Form 3160-5 (June 2015)

## **UNITED STATES** DEPARTMENT OF THE INTERIOR BUREAU OF LAND MANAGEMENT

De4 46!									
Do not use thi abandoned wel	6. If Indian, Allottee or Tribe Name								
SUBMIT IN 1	7. If Unit or CA/Agree	ment, Name and/or No.							
Type of Well     ☐ Gas Well    ☐ Oth	8. Well Name and No. MITHCELL 21 FEDERAL 2								
Name of Operator     OXY USA INCORPORATED	9. API Well No. 30-015-28710-00-S1								
3a. Address 5 GREENWAY PLAZA SUITE HOUSTON, TX 77046-0521	110	3b. Phone No. (i Ph: 432.685.	include area code) 5717		10. Field and Pool or E CEDAR CANYO	exploratory Area

OXY USA Inc. - Proposed Mitchell 21 Federal #2 API No. 30-015-28710

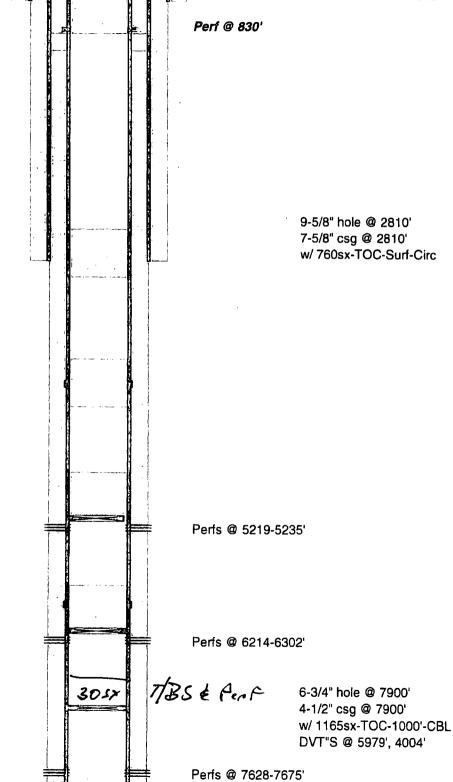
2966 25sx @ <del>2860</del>-2610' WOC-Tag

25sx @ 4060-3810' WOC-Tag

CIBP @ 5169' w/ 25sx to 4920'

CIBP @ 6164' w/ 25sx to 5929'

13. Describe Proposed or Completed Operation: Clearly state all pertinent details, including estimated starting date of any proposed work and approximate duration thereof. If the proposal is to deepen directionally or recomplete horizontally, give subsurface locations and measured and true vertical depths of all pertinent markers and zones. Attach the Bond under which the work will be performed or provide the Bond No. on file with BLM/BIA. Required subsequent reports must be filed within 30 days following completion of the involved operations. If the operation results in a multiple completion or recompletion in a new interval, a Form 3160-4 must be filed once testing has been completed. Final Abandonment Notices must be filed only after all requirements, including reclamation, have been completed and the operator has determined that the site is ready for final inspection.  TD-7900' PBTD-7000' Perfs-5219-6302' CIBP-7000'  TD-7900' PBTD-7000' Perfs-5219-6302' CIBP-7000'  TO-3/4" 40.5# csg @ 533' w/ 510sx, 14-3/4" hole, TOC-Surf-Circ  7-5/8" 29.7# csg @ 2810' w/ 760sx, 9-5/8" hole, TOC-Surf-Circ  4-1/2" 11.6# csg @ 7900' DVT @ 5979',4004' w/1165sx,6-3/4" hole, TOC-1000'-CBL  RIH & set CIBP @ 6164' w/ 25sx cmt to 5929' wo C Toc (DVT)  RRH& Set CIBP @ 6164' w/ 25sx cmt to 5929' wo C Toc (DVT)  RRH& Set CIBP @ 6164' w/ 25sx cmt to 5929' wo C Toc (DVT)  M&P 25sx cmt @ 4060-3810' WOC-Tag  M&P 25sx cmt @ 5169' w/ 25sx cmt to 5929' wo C Toc (DVT)  SEE ATTACHED FOR CONDITIONS OF APPROVAL

(Instructions on page 2) \*\* BLM REVISED \*\* BLM REVISED \*\* BLM REVISED \*\* BLM REVISED \*\*
